TECHNICAL INFORMATION

64123
(Page 1 of 2)

Subject	▶ Addition of Needle Bearing to Blade Case Complete or Gear Housing Complete
For Models	▶ 4157KB, 5007B, 5007NB, 5007NBA, 5007NH, 5007NL, 5007S, 5008B, 5008NB, 5008NBA, 5057KB, M513
Country	▶ All countries
Description	▶ See below.

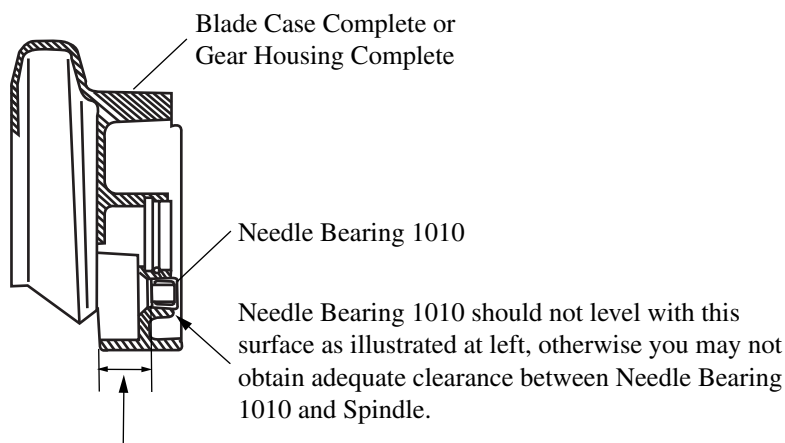
Needle Bearing 1010 has been assembled into Blade Case Complete or Gear Housing Complete.

▶ Current	▶ New
 <p>Needle Bearing 1010 is not pre-installed.</p>	 <p>Needle Bearing 1010 is pre-installed.</p>

When replacing Needle Bearing 1010 itself, install it on the Blade Case Complete or Gear Housing Complete as illustrated below.

Distance must be 22.3-22.7mm.
